Comments on 2019/5709/P have been received by the council.

LETTER OF OBJECTION

Prepared by Get Planning & Architecture against application 2019/5709/P,
which is for:

*"Erection of two storey plus basement building, to provide 2 x 3 bed units.
Excavation for basement extension with front light well and rear sunken
garden. Demolition of 12 garages and erection of 5 replacement garages at
Parsifal House, 521 Finchley Road, London NW3 7BT"*

ABOVE: Photographs of windows most affected areas in 1G Parsifal Road

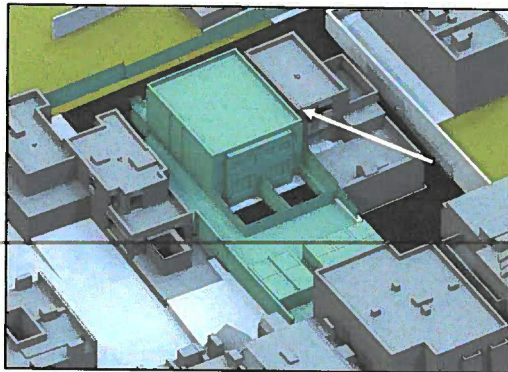
- b. Mr Wong and his family are concerned that, due to the proposed placement of the new building, the proposal will greatly affect available sunlight to their property on the NW elevation where the development will be directly opposite. The 2 storey extension would potentially overlook and greatly affect the amount of natural light to their roof garden and will deprive 1G of natural light to the bedroom, bathroom and the single stair circulation space.

- c. The effect on the light into the stairwell, though not a habitable space, will cause a potential safety issue by limiting visibility to the only circulation space to the first floor. The objectors will require additional lighting in this space to mitigate the significant reduction of light.

ABOVE: Daylight Study conducted by submitting Architects showing proximity to 1G

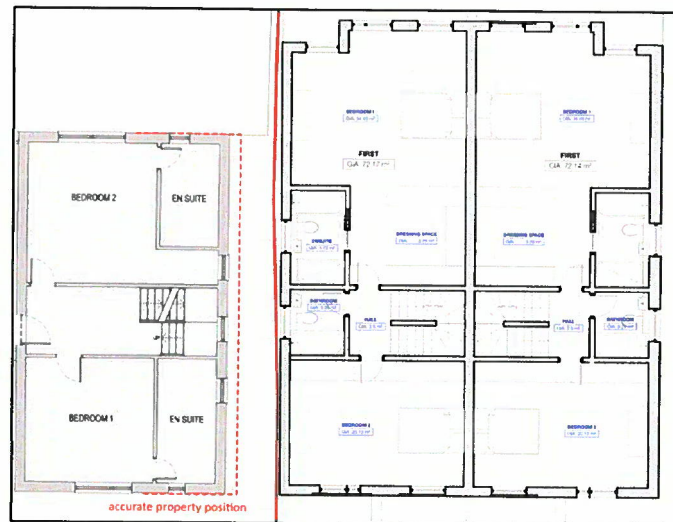
- g. The figures relied upon within the study appear to be estimated and not definitive as locations of rooms and windows within 1G are not accurately indicated within the model or the submitted drawings.
- h. Although it is noted in the submitted daylight/sunlight study that the VSC (Vertical Sky Component) for the windows are within the BRE guidelines of >27% it is also known that this target value is derived from a low density suburban housing model, which this particular area is not.

- i. It appears that the proposal does not recognise the importance of daylighting to the occupants of 1G particularly given it unnecessarily overshadows the roof garden and affects 3 windows on the side elevation and 3 windows and 2 bifold doors on the rear elevation.

ABOVE: View of existing alleyway and View from Garden where proposed building will protrude past 1G building line.

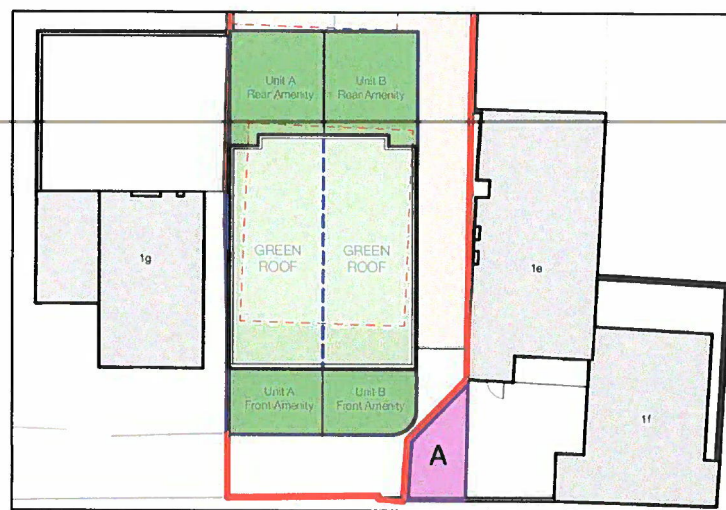
- d. It should also be considered that its proximity to the boundary line leaves less than 1.2m between a solid wall and 1G Parsifal Road. This is surely not enough distance between two detached houses, and will result in a cramped and overbearing on the street scene.

- e. The Design and Access Statement did note that the design of the building does take care in limiting windows on the elevation closest to the boundaries however does not take into account that this results in a long solid brickface wall which significantly reduces the quality of outlook experienced at 1G Parsifal.
- f. The Council is requested to review this proposal keeping in mind there is no gap given between the boundary line and the 2 storey development and though not specifically noted in the Camden SPD for Design, should still be considered unacceptable.
